Lot 23
Phase RC
Model -Dover (42-05) Elev A
DA ZHANG

Colours Upgrade Report
Kings Ridge Print Date:08-Nov-12

DOVER
ELEVATION A - 2860 SQ. FT.
ELEVATION B - 2817 SQ. FT.

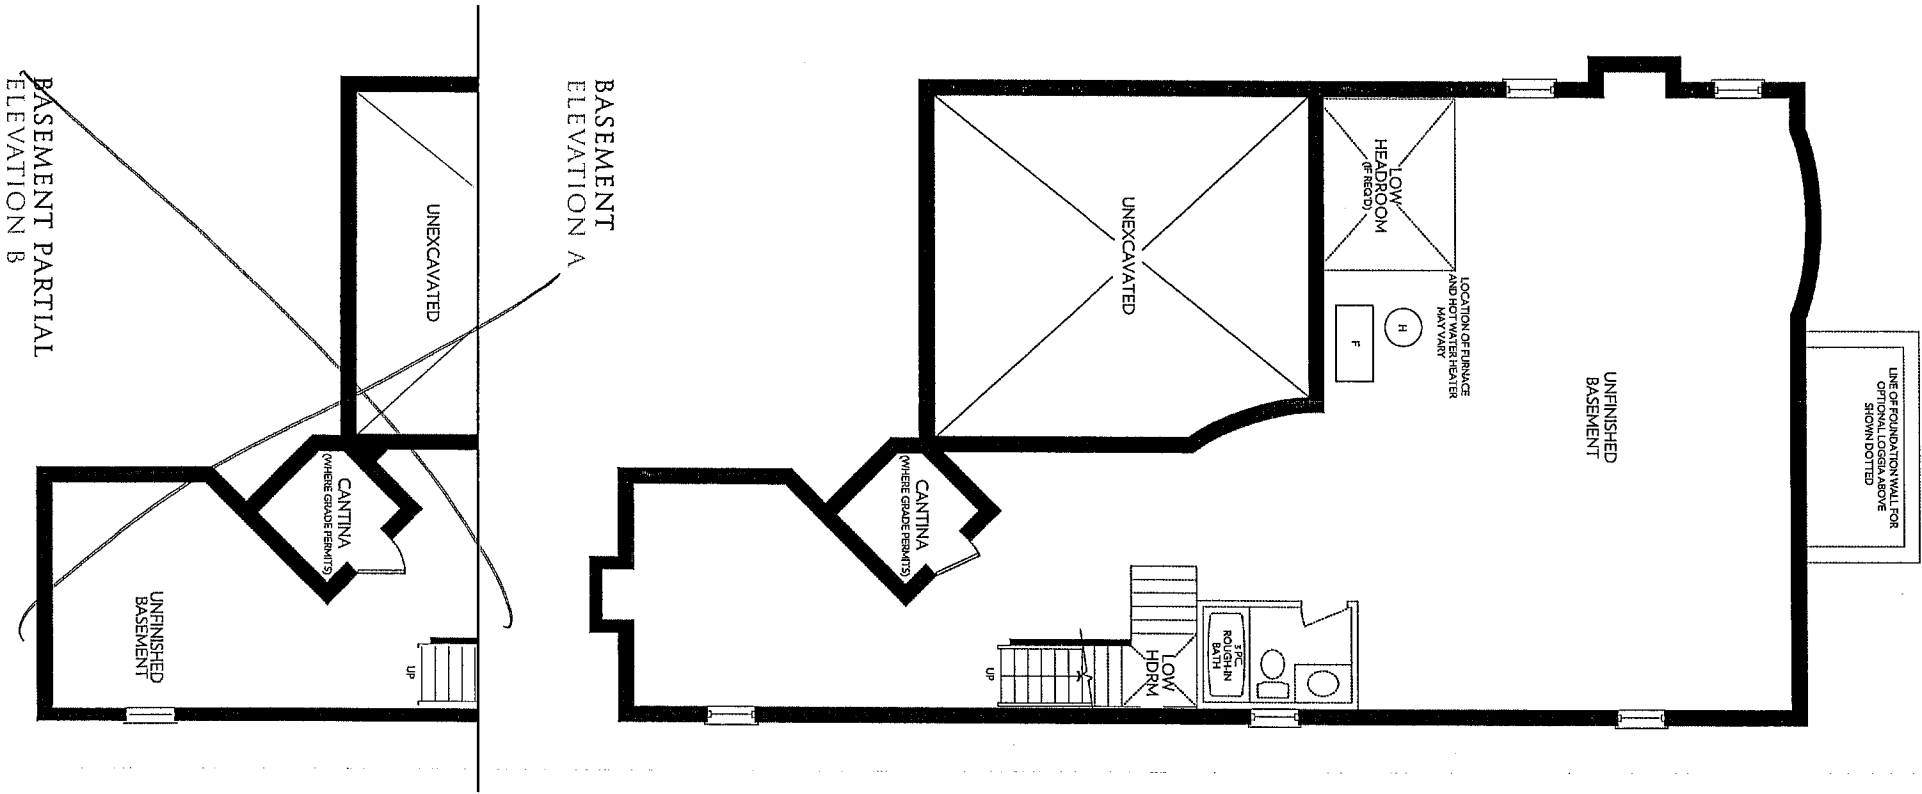
6'0" x 8'
(6) - 7 ft.
Round Hollow

GROUND FLOOR ELEV. 'A'

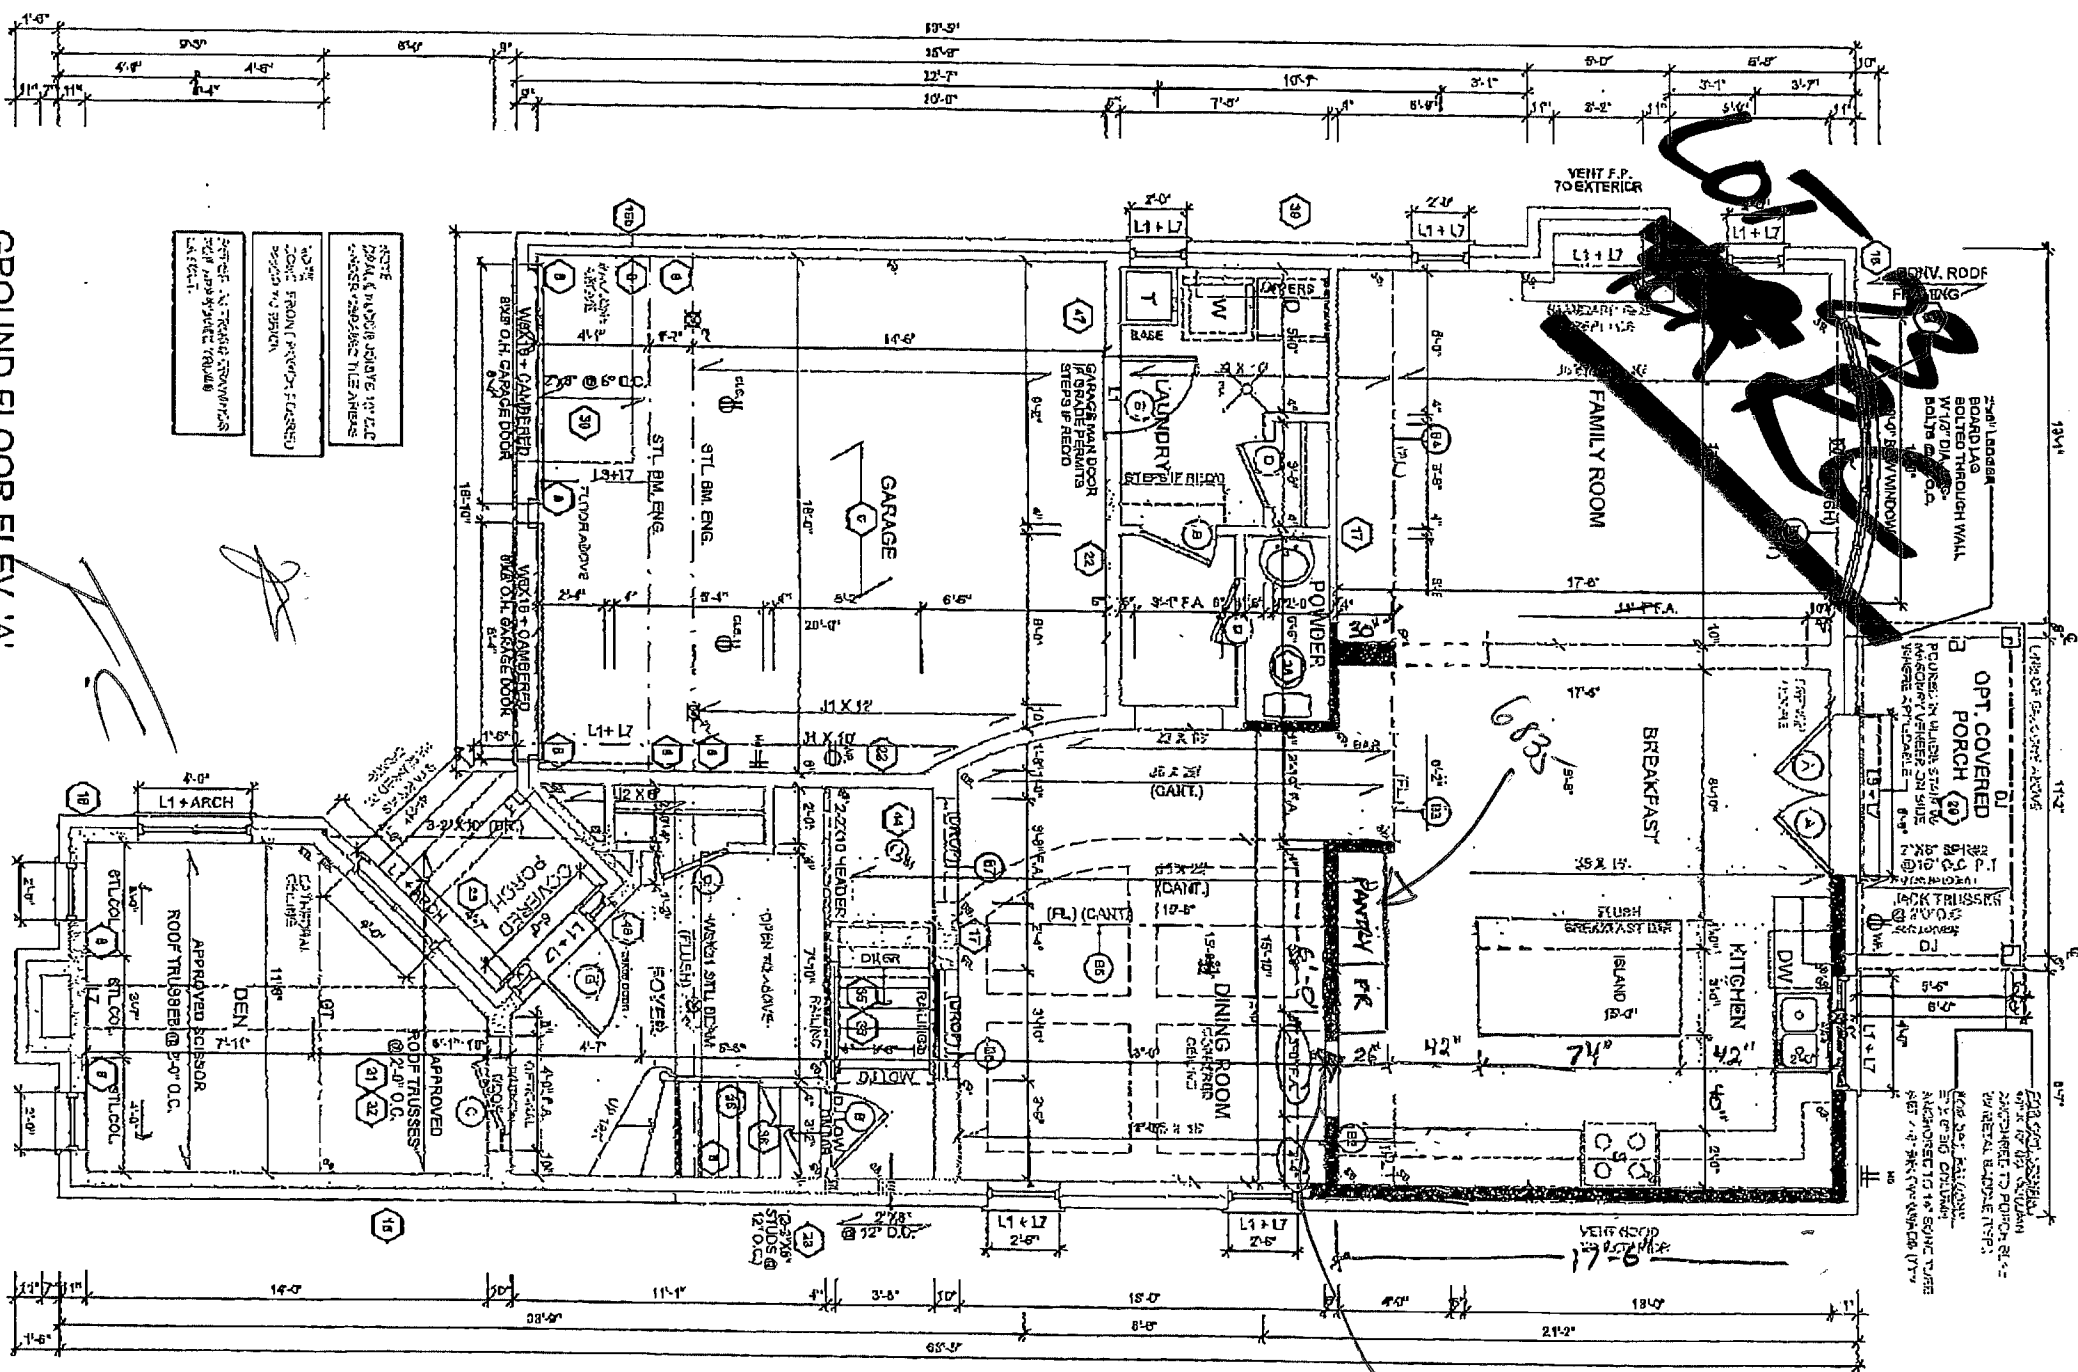
ID	Description	Invoice	Date Ordered	
6278	FRAMING / TRIM - 2ND FLOOR: Six (6) - 7 foot doors to upper hallway area, hollow core	1252		
6279	HVAC - KITCHEN: Gas line to stove	1252		
6833	FRAMING - KITCHEN: Delete wall between servery and kitchen	1252		
6834	FRAMING - KITCHEN: Move fridge wall back 24 inches in line with servery wall between dining room and servery	1252		
6835	FRAMING - KITCHEN: Make a 30 inch deep wall beside pantry - needs to carry a point load	1252		
6836	TILE - KITCHEN: Additional standard ceramic in extended kitchen	1252
